Vermont Agency of Transportation
RECEIVED
Revised EIN BRF 0241 (39) - Precast Drop Stringing Submittal - Bond.pdf

RESUBMIT YES Rejected
BY KH DATE 1-15-2014

TOWN OF BARNARD
VT ROUTE 12, MAJOR COLLECTOR
BRIDGE NO.: 25 PROJECT NO.: ER BRF 0241(39)

COVER SHEET

2 / F1 PRESTRESSED APPROACH SLAB & NEXT BEAM LAYOUT

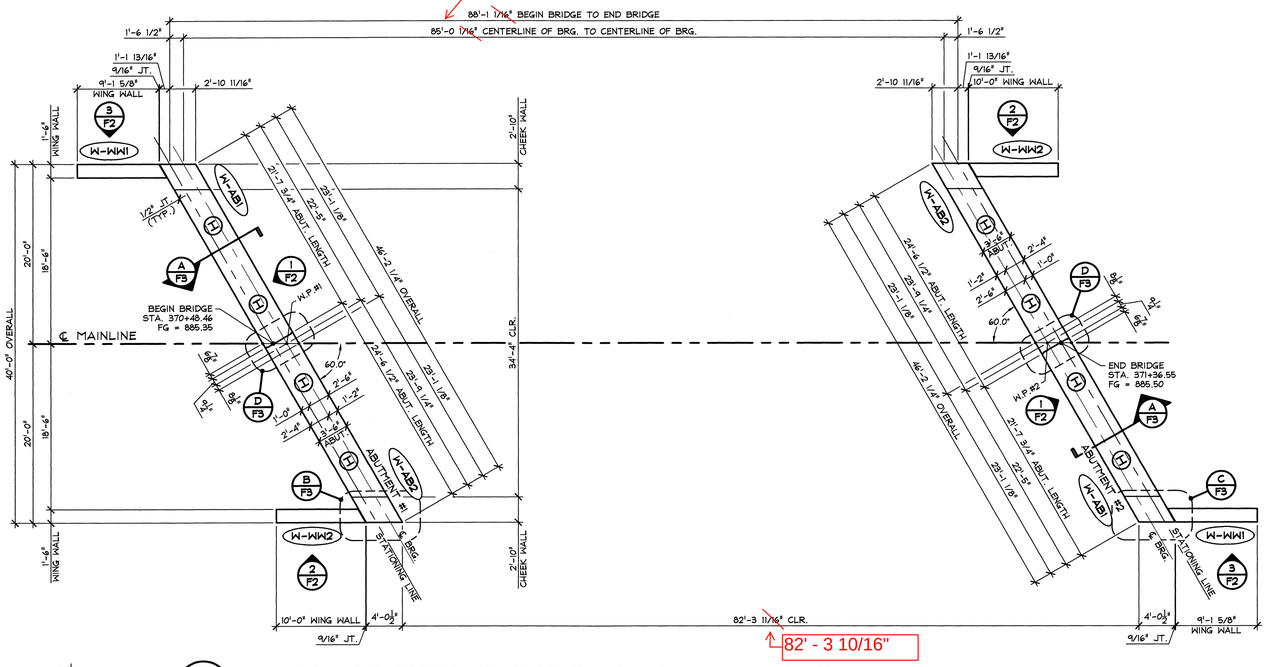
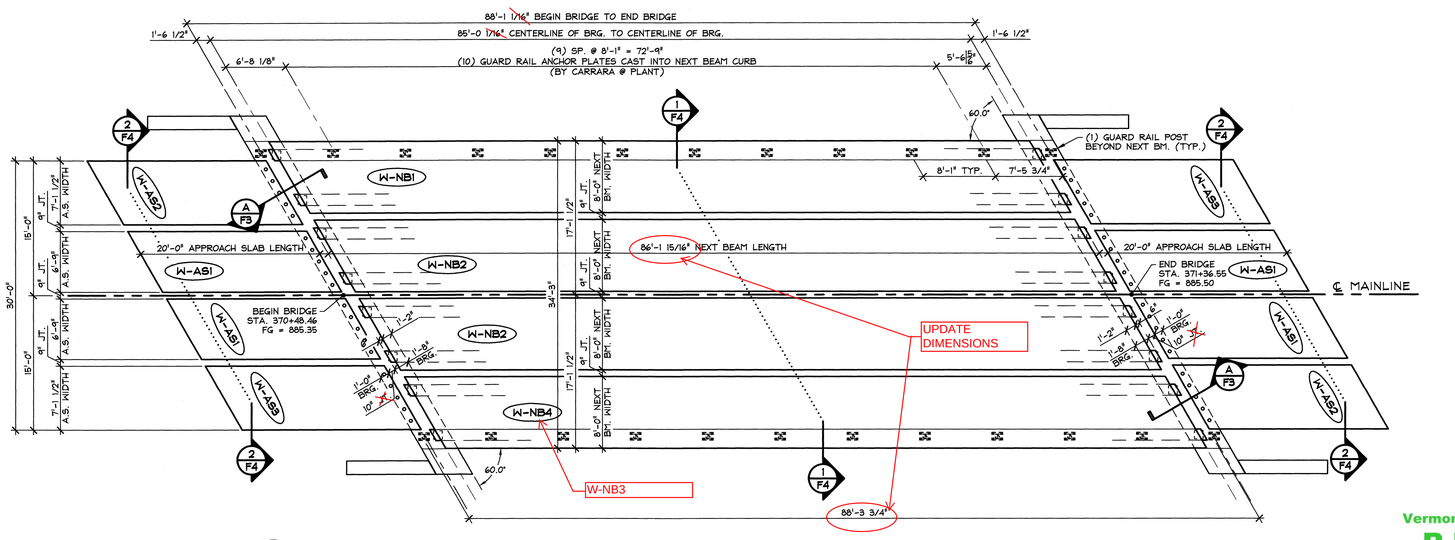
CL -CL is 85.00 ft. WP are from CL bearing, adjust dimensions.

A F3 BEARING SECTION
NEXT BEAM STEM BEARING 3/4" = 1'-0"

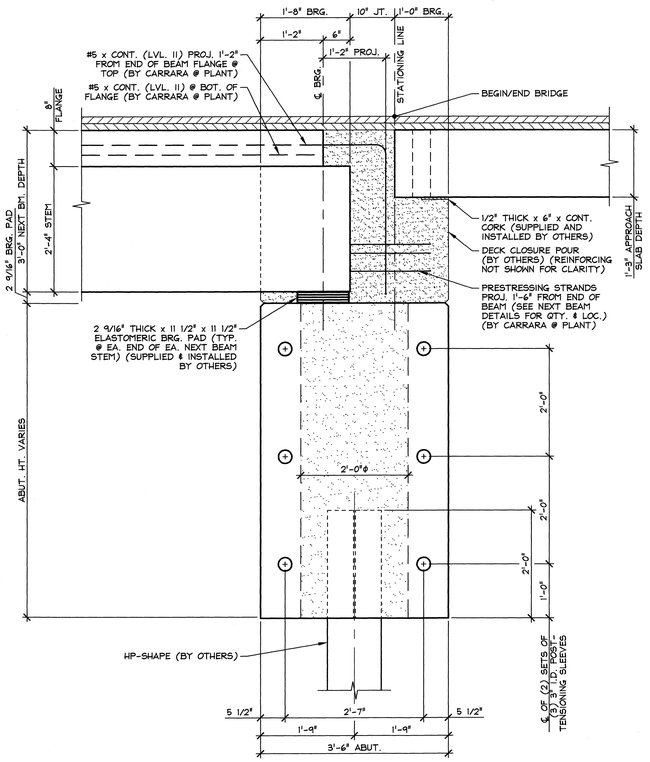
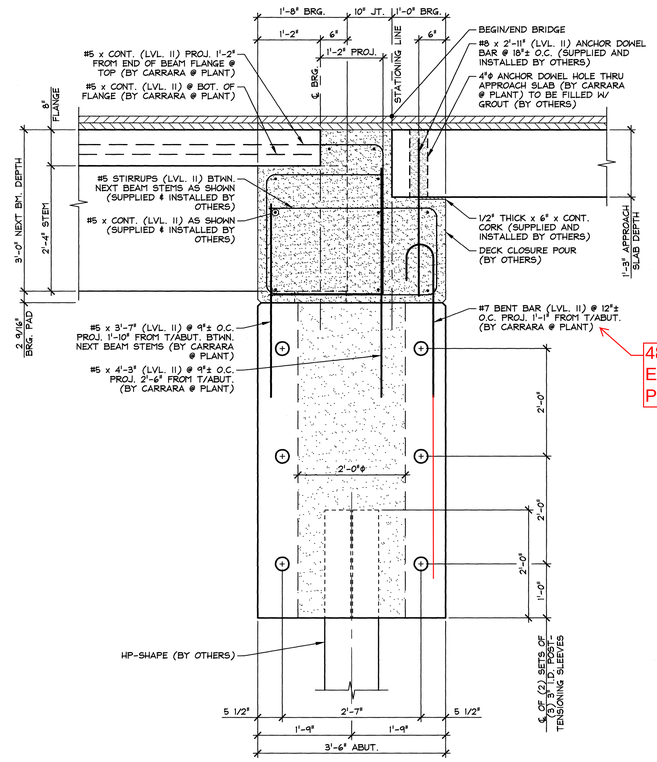
48" MIN EMBEDMENT INTO PILE CAP.

PLAN VIEW IN FORM "W-WW1"

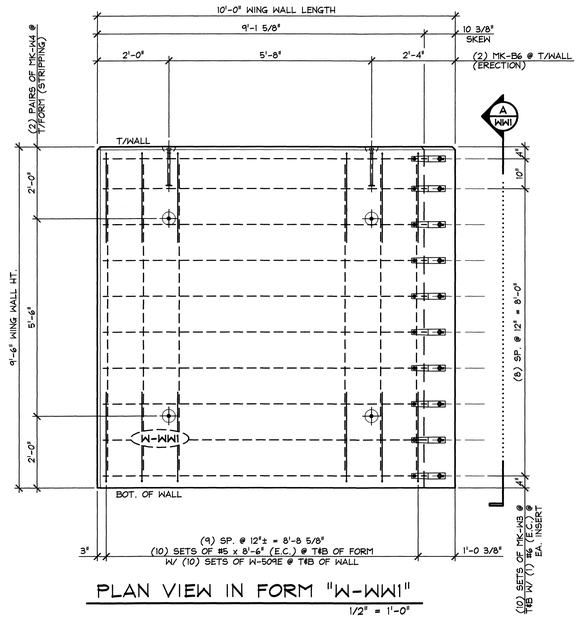
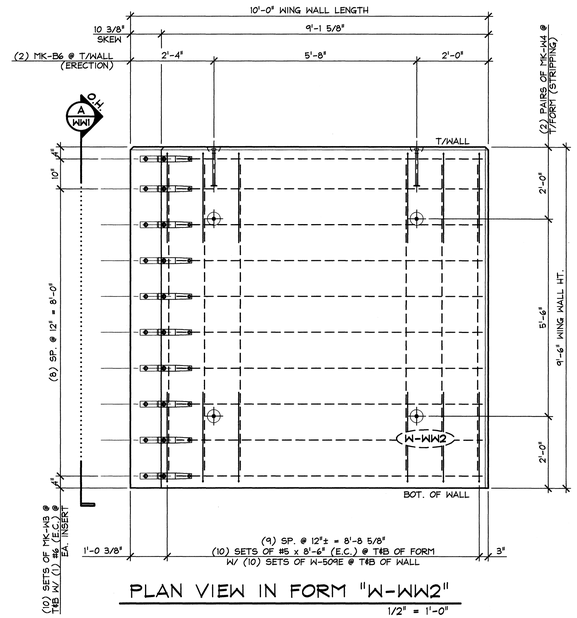
As per Addendum #1: 81. Notice to Bidders:
All reinforcing steel in wingwalls shall meet the requirements of Section 507 for Level II Reinforcing. All Mechanical Connectors in wingwalls shall meet the requirements of Section 507 for Level I (Epoxy Coated) Reinforcing.
